**Re: Appeal of Walt Ranch Vineyard Conversion Project (ECP P11-00205-ECPA) -
New Evidence.**

Subject: Circle Oaks Drive
Napa County, California
GEOLOGIC AND GEOTECHNICAL REVIEW & RECONNAISSANCE

**RE: Request for Presentation of Additional Evidence for Good Cause
Walt Ranch Erosion Control Plan (P11-00205-ECPA)**

Project No. VV4147
Circle Oaks Drive, Napa County
Site Map – Circle Oaks Drive Area

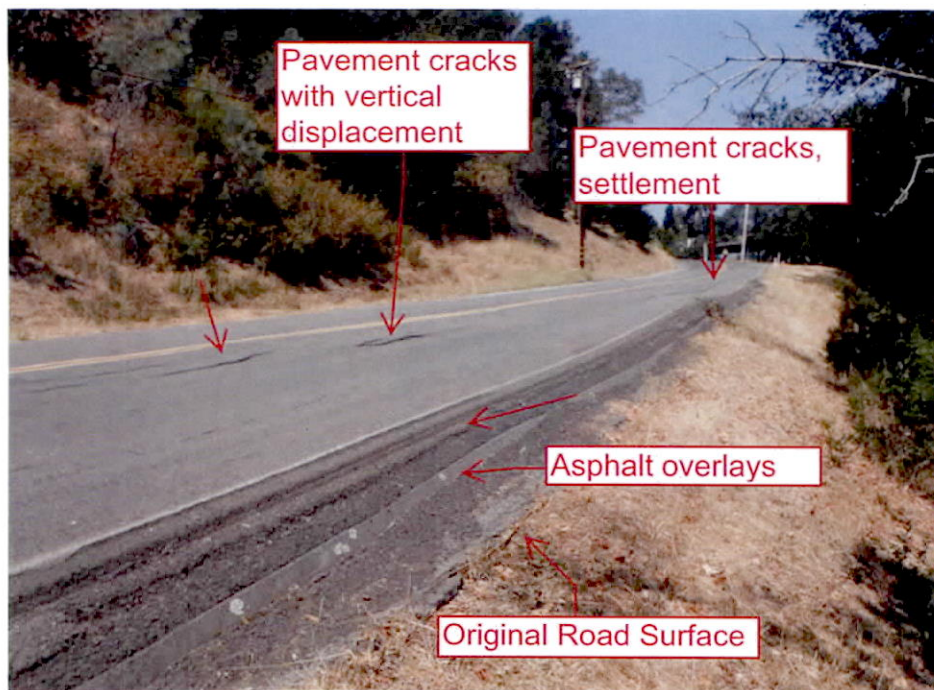
Two areas of extensive pavement distress were observed. The largest area (Area A) is along a straight portion of Circle Oaks Drive approximately 300 feet north of the intersection with

Sunnyhill Lane. The second area (Area B) is located along the inside of a bend approximately 300 feet south of the intersection with Rockrose Court.

Project No. VV4147
Circle Oaks Drive, Napa County
Area A Photographs

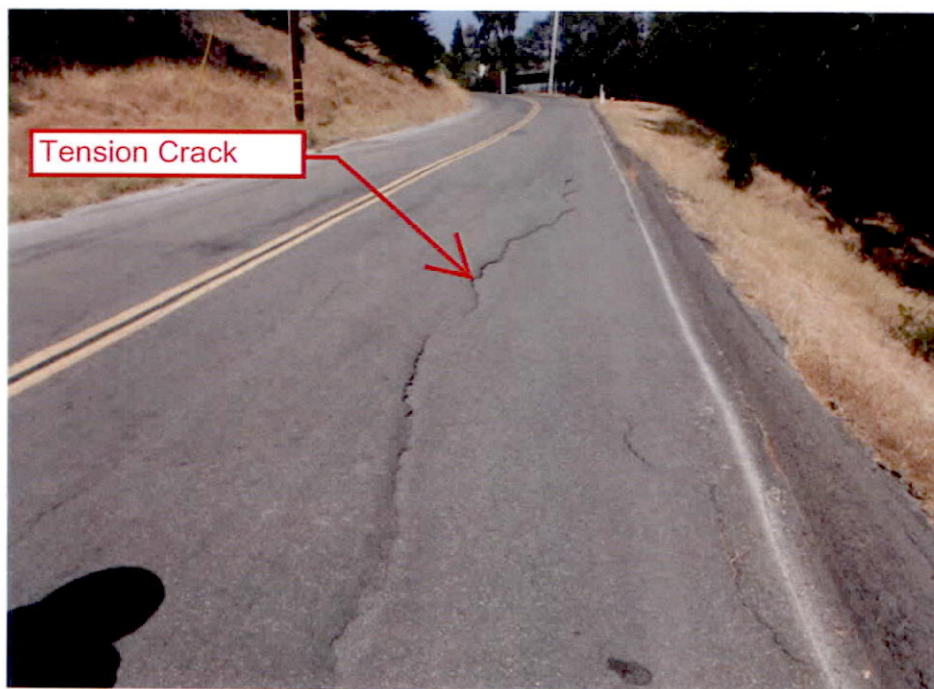
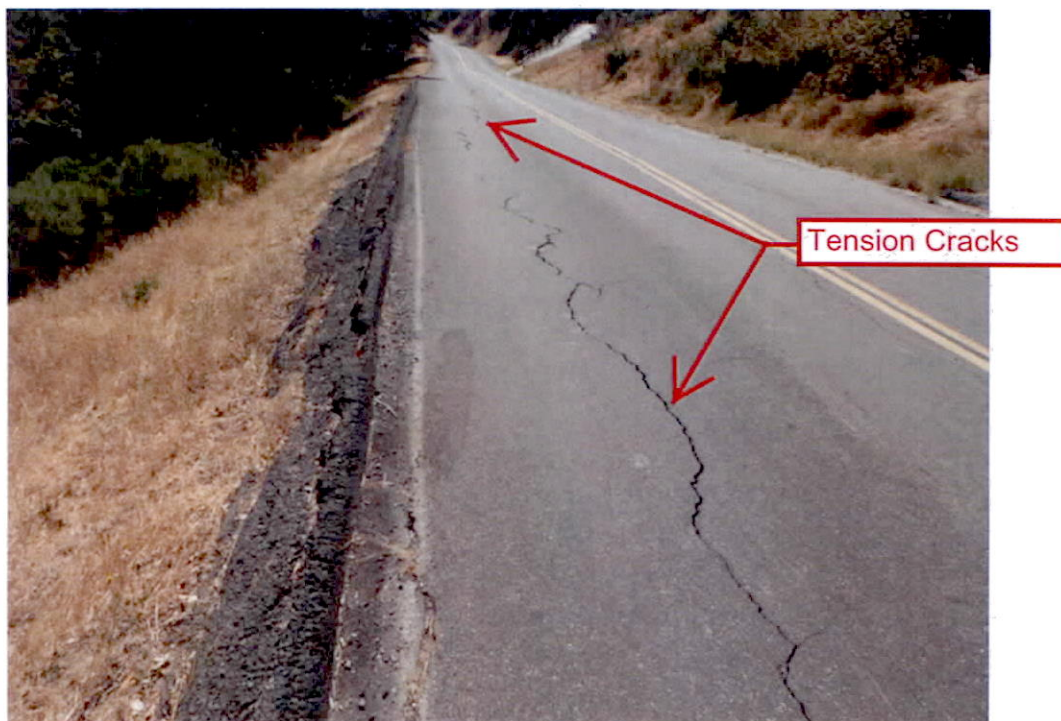
Area A includes an area of extensive road settlement and cracking located along a linear portion of Circle Oaks Drive. The road in this area was constructed by cut/fill techniques and the eastern lane consists of a large fill embankment. The fill bank appears to extend down the slope approximately 25 vertical feet and has inclinations of about 1.5H:1V (horizontal to vertical). In this area we observed severe pavement cracks over a zone approximately 300 feet in length (see attached photographs). The cracks range up to approximately 1 inch in width and extend approximately to the centerline of the existing road. Some of these cracks have vertical offsets in excess of 1 inch. In addition, our observations found that the area has been repeatedly repaved to compensate for previous settlement in the area of more than 1 foot. Circle Oaks

Drive in this area is not adequately sloped into the hill, but rather towards the outer embankment fill slope.

Our observations also indicate that during times of high flow from heavy rainfall events, water coming down the road sheets flows onto the roadway reaching the area of the cracks and top of fill slope. According to Mr. Heitzman, water does flow across the roadway in this area during major storms. We also observed evidence of erosion on the slope below this area. In our opinion, the future stability of the road embankment in this area is a critical concern. The fill portion of the roadway roughly northeast of the centerline is already experiencing excessive movement with cumulative movement since construction of more than 12 inches. The numerous open cracks allow the infiltration of water into the subgrade and the underlying fill. Experience on previous projects has shown that embankments of this type can fail suddenly as a result of heavy rain and the infiltration of water into road cracks. The result can be failure of the fill embankment and loss of the road, as well as underground utilities.

Of particular concern is the ongoing subsidence and pavement distress occurring in Area A. Our observations indicate that more than one foot of vertical movement has occurred in the area since construction of the road. The observed cracking indicates that soil creep, settlement and instability of the roadway fill is ongoing. Experience on similar projects has shown that

In our opinion, the County should retain a qualified Geotechnical Engineering consultant to perform an evaluation of both areas and provide recommendations for pavement rehabilitation and slope stabilization. The investigation should include test borings and laboratory shear strength and R-value testing to establish the subsurface soil conditions and to determine the embankment slope stability factor of safety. Geotechnical road stabilization and repair recommendations should be provided based on the findings of the field and lab investigation. A Civil Engineering consultant should also be retained to evaluate the site and road hydraulics, perform an analysis of surface water drainage and provide mitigative design drawings. A traffic study should also be performed to evaluate the appropriate traffic index and pavement section.

Project No. VV4147
Circle Oaks Drive, Napa County
Area A Photographs

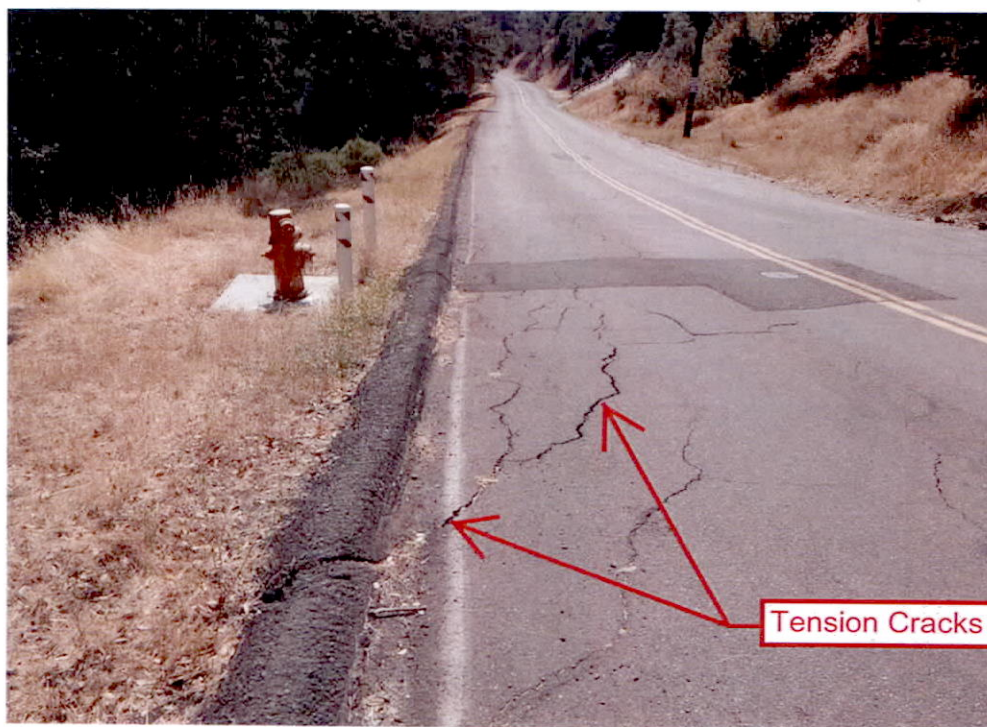
Area A – pavement cracks with vertical displacement
